## **Service Bulletin**

Bulletin No.: 21-NA-212

Subject: Information on Power Front Seat Adjuster Track Service Part Availability Separate from Complete Seat Cushion Frame Assembly

5902829

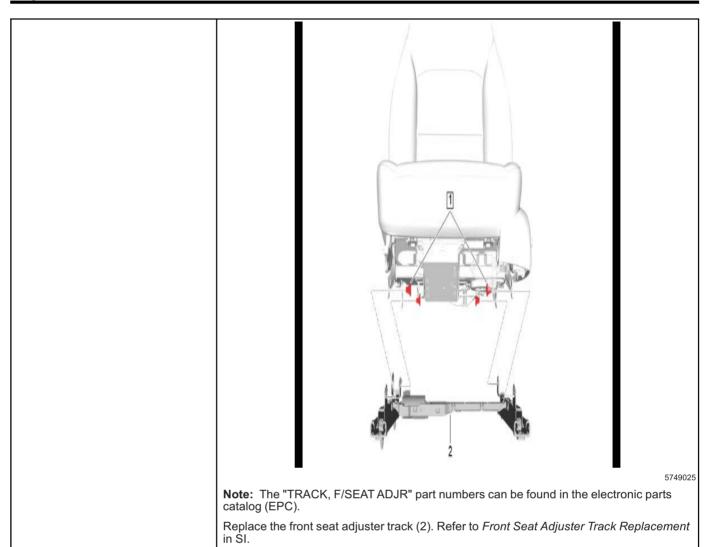
**Caution:** To remove the new power front seat adjuster track from the shipping container, lift it up with one hand on each track. Do not lift the power front seat adjuster track by holding the bridge; it may cause damage to the material.
